Metropolitan Planning Commission

Staff Report

August 8, 2013

2013SP-026-001
9TH & CHEATHAM COTTAGES
Map 081-12, Parcel(s) 309-311, 470
North Nashville
19 - Erica S. Gilmore

Proposed Specific Plan

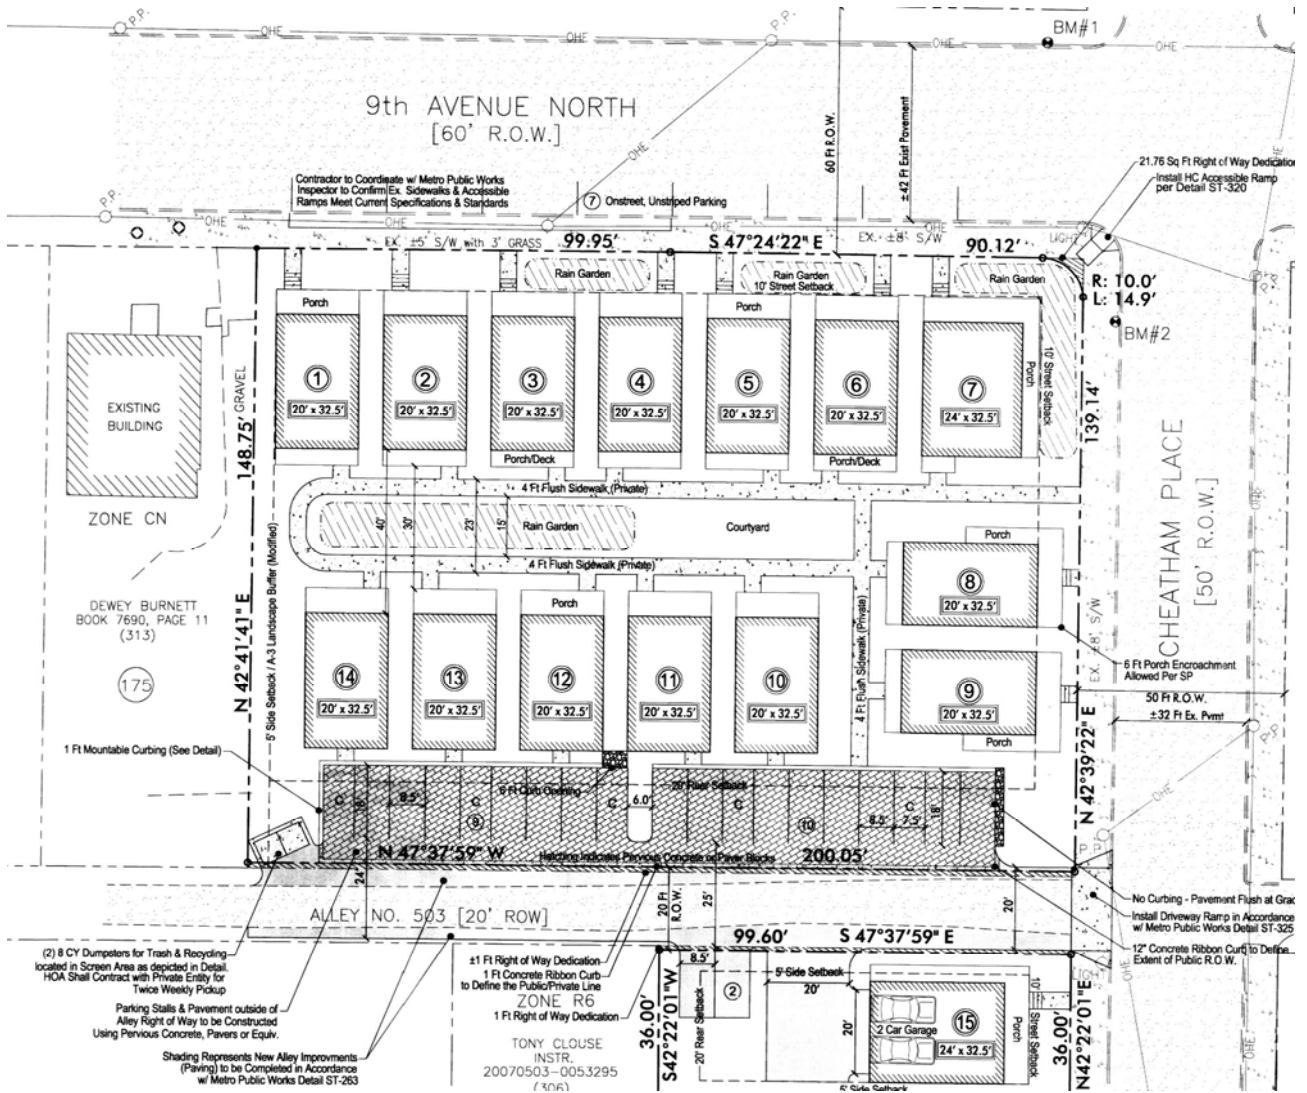
The plan identifies 15 detached residential units. Seven units front onto 9th Avenue and three units front onto Cheatham Place. Out of the three units along Cheatham Place, one will be located on the west side of the alley and will be on a separate lot. Five units front onto a central open space which is framed by the units along 9th and Cheatham Place. The units fronting on 9th Avenue and Cheatham Place have porches on the front and at the back, which front onto the open space. The plan also calls for a buffer along the western property line which is intended to buffer this development from the neighboring commercial (CL) district.

Vehicular access is provided from the alley. A total of 23 parking spaces are provided, including two located in the garage for unit fifteen. The plan also calls for an additional seven on-street spaces.

This request is consistent with the T4 NM land use policy and infill area designation and meets several critical planning goals. Staff recommends approval with conditions.

1. Permitted land uses are limited to single-family and multi-family residential.
2. For any development standards, regulations and requirements not specifically shown on the SP plan and/or included as a condition of Commission or Council approval, the property shall be subject to the standards, regulations and requirements of the RM20 zoning district as of the date of the applicable request or application.

3. A corrected copy of the preliminary SP plan incorporating the conditions of approval by the Planning Commission and Council shall be provided to the Planning Department prior to the filing of any additional development applications for this property, and in any event no later than 120 days after the effective date of the enacting ordinance. The corrected copy provided to the Planning Department shall include printed copy of the preliminary SP plan and a single PDF that contains the plan and all related SP documents. If a corrected copy of the SP plan incorporating the conditions therein is not provided to the Planning Department within 120 days of the effective date of the enacting ordinance, then the corrected copy of the SP plan shall be presented to the Metro Council as an amendment to this SP ordinance prior to approval of any grading, clearing, grubbing, final site plan, or any other development application for the property.

Proposed Specific Plan

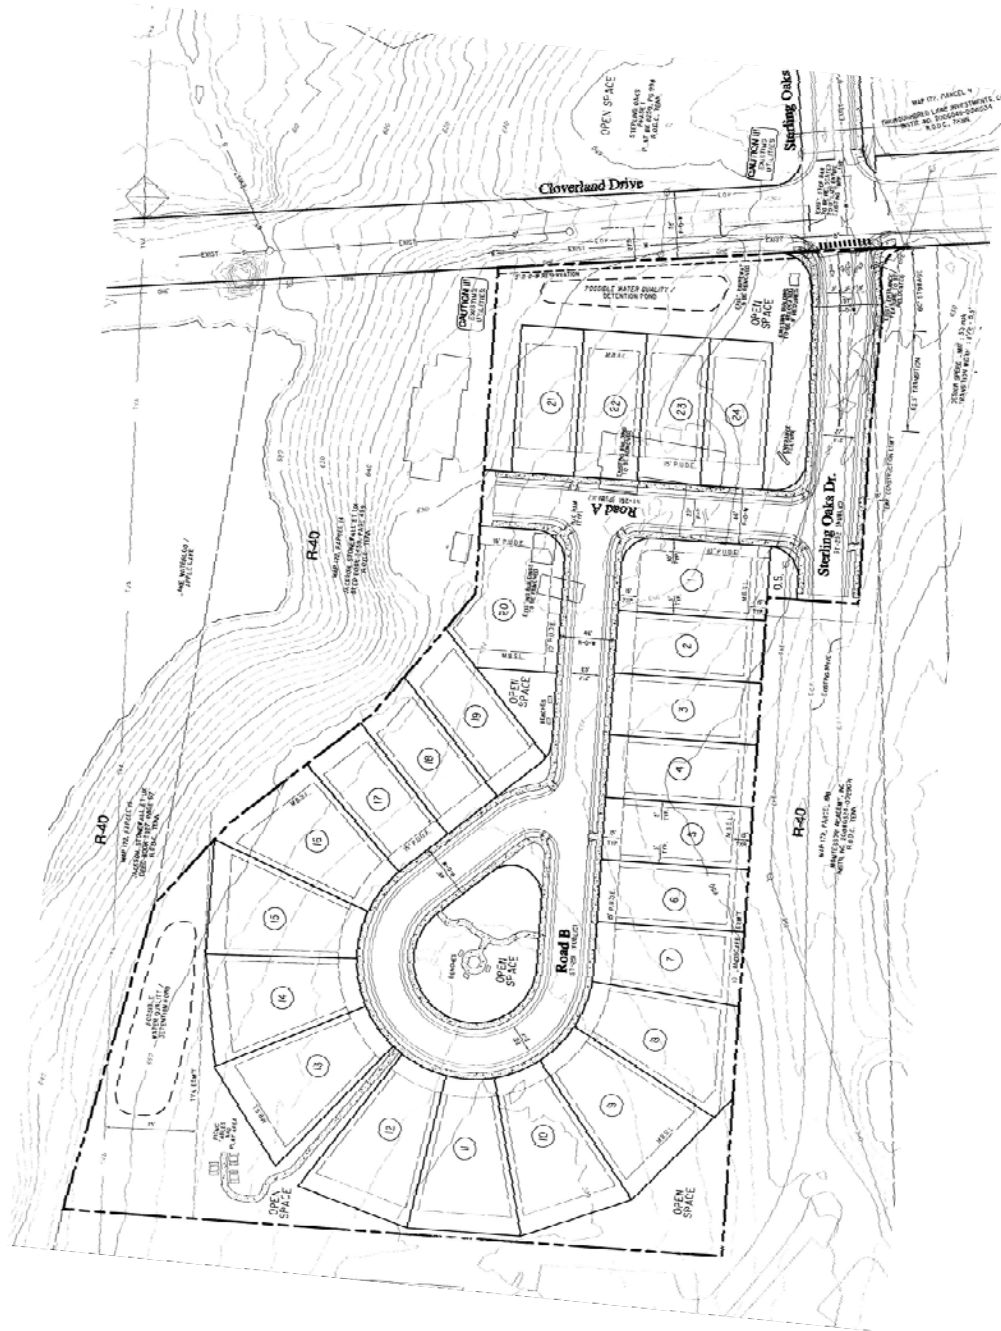
Variations or specific findings to several sections of the Subdivision Regulations would be required to implement the proposed SP. Though subdivisions are filed as separate applications from zone change applications, the Zoning Code requires SPs to follow the Subdivision Regulations. SPs are not intended to circumvent the Subdivision Regulations. Staff is required to review this SP plan against the Zoning Code and Subdivision Regulations to ensure it complies with both. The following is a list of Subdivision Regulation requirements that this SP does not meet.

The Subdivision Regulations require the orientation of dwelling units toward arterial or collector streets. Because Cloverland Drive is an arterial street, the Subdivision Regulations would require building frontages to face Cloverland Drive. Instead, the SP includes 4 lots along Cloverland Drive that would face an internal street running parallel to Cloverland Drive, with the backs of the lots facing Cloverland Drive. These four proposed lots do not meet the Subdivision Regulations.

The Subdivision Regulations permit cul-de-sacs in situations where topographic features or configuration of property would prevent street connections. The SP proposal is a cul-de-sac design. However, the applicant has not shown a topographic reason or a property configuration reason for

the cul-de-sac based on a topographic or property configuration reason. Topography does not appear to be an issue on this site. The use of a portion of the adjacent Montessori school property for a public street entrance shows that the redevelopment of this adjacent property could be expected in the future. Staff finds that this use of a cul-de-sac does not meet the Subdivision Regulations.

The Subdivision Regulations include a requirement for the planning of future streets and building locations when future subdivision of land can be anticipated. Because the proposed Sterling Oaks Drive connection to Cloverland Drive could be expected to extend farther to the south through the school property in the future, this SP should include a plan for that future development and should include a comprehensive street system that does not include the proposed double-frontage lots and cul-de-sacs that are not permitted by the Subdivision Regulations. Without a plan for future street connections on the Montessori school property, this SP plan does not comply with the Subdivision Regulations, which require a plan of resubdivision where the Planning Commission has reason to believe that land will be resubdivided into smaller building sites.

Without a plan for development of the adjacent parcel, development of the two adjacent parcels will result in a piecemeal development pattern with unnecessary cul-de-sacs, double-frontage lots, and relatively few street connections. Because this SP does not include a plan for the development of the adjacent parcel, and does not anticipate future street connections to the adjacent parcel, this SP does not meet the design principle of the RLM policy to provide a street network with a high level of connectivity:

1. Subdivisions along arterial streets require lots that face the arterial street. Staff has not determined that a unique condition exists on the property that would permit lots that do not face Cloverland Drive.
2. A topographic or property configuration reason must be present to permit a cul-de-sac. There does not appear to be a reason for a cul-de-sac based on these factors.
3. Where future subdivision of land is foreseen, the Subdivision Regulations require a plan for that future subdivision. The proposal for a stub street to the adjacent Montessori school property points to the need for a conceptual street plan for its future redevelopment.

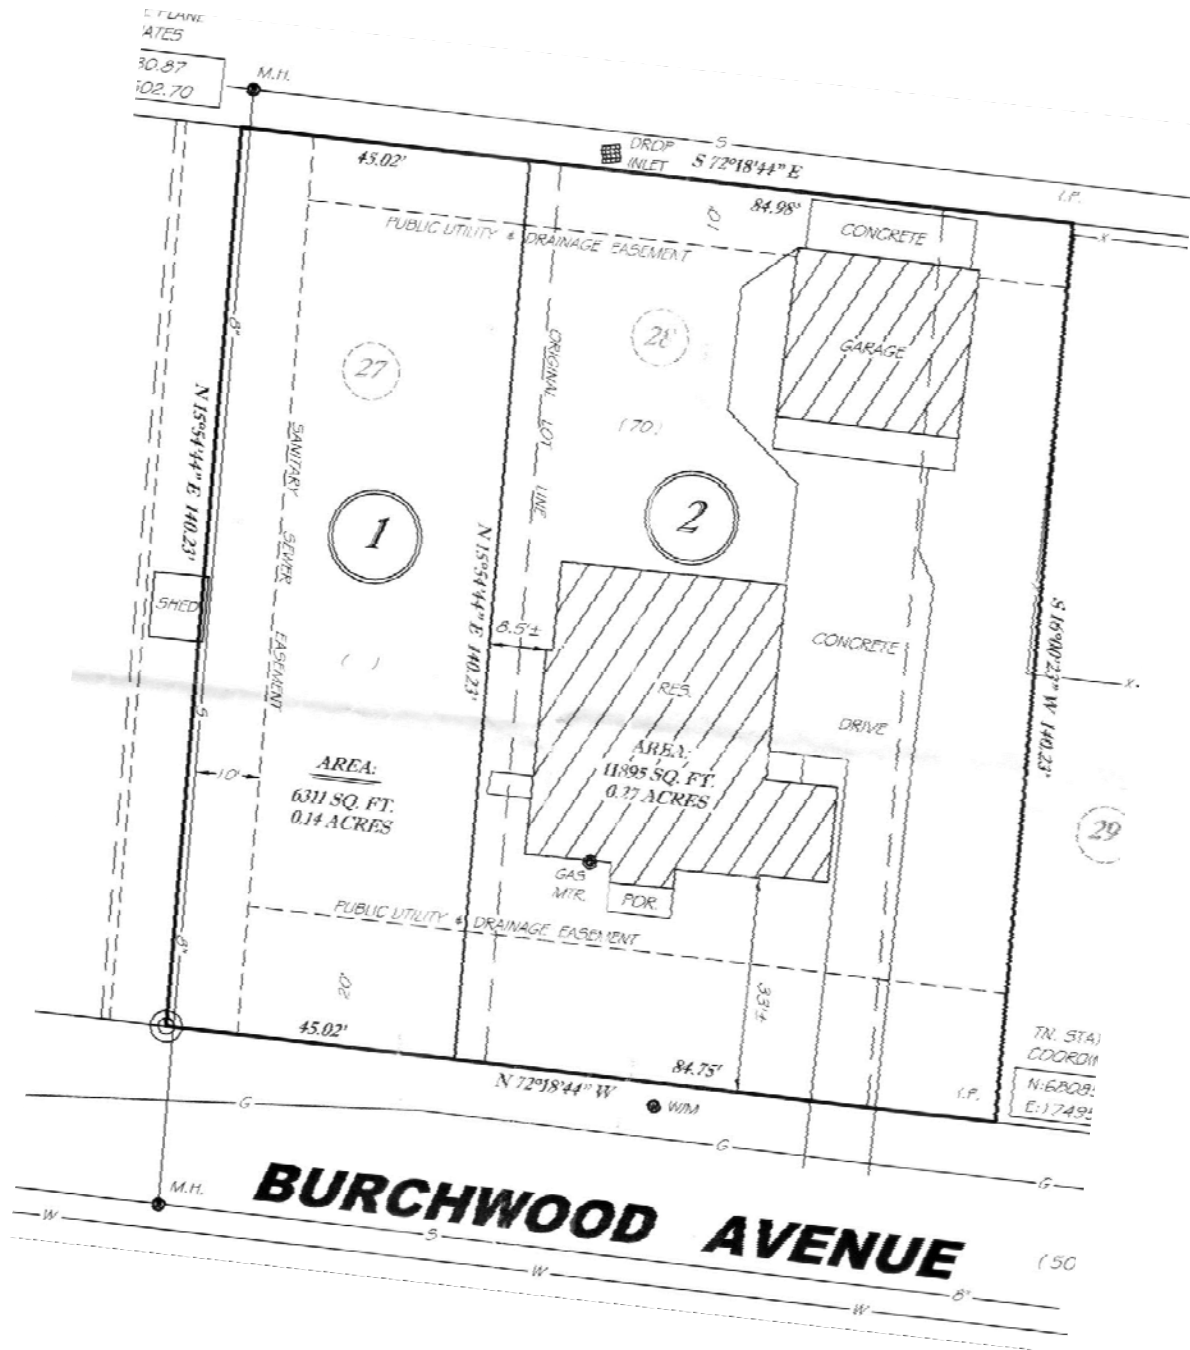
Because one of the two lots will have a lot frontage of less than 50 feet, a shared driveway is required. However, the Subdivision Regulations allow the Planning Commission to waive this requirement when existing conditions would prevent a shared access drive. The subdivision layout anticipates keeping the existing house on the site. The current layout of the existing house, with a driveway on its east side, would not allow a shared access drive to Lot 1 because the house and backyard within the Lot 2 would not allow the extension of the access to Lot 2.

- Cite the correct FEMA panel number to plat (228 F).

- The developer's final construction drawings shall comply with the design regulations established by the Department of Public Works. Final design may vary based on field conditions.
- If sidewalks are required, then they should be shown on the plan per Public Works standards with the required curb and gutter and grass strip.
- Indicate and label the existing EOP.
- Label and dimension the ROW at the property corners.

1. Prior to recordation of the plat, a note shall be added to the plat limiting development to single-family detached only.
2. Sidewalks are required along the Burchwood Avenue frontage of the proposed subdivision. Prior to final plat recordation, one of the options must be chosen related to sidewalks:

3. Prior to recordation, the correct FEMA panel number shall be added to the plat.
4. The developer's final construction drawings shall comply with the design regulations established by the Department of Public Works. Final design may vary based on field conditions.

5. Prior to recordation, the plat shall be revised to indicate and label the existing edge of pavement.
6. Prior to recordation the right of way shall be labeled and dimensioned at the property corners on the plat.
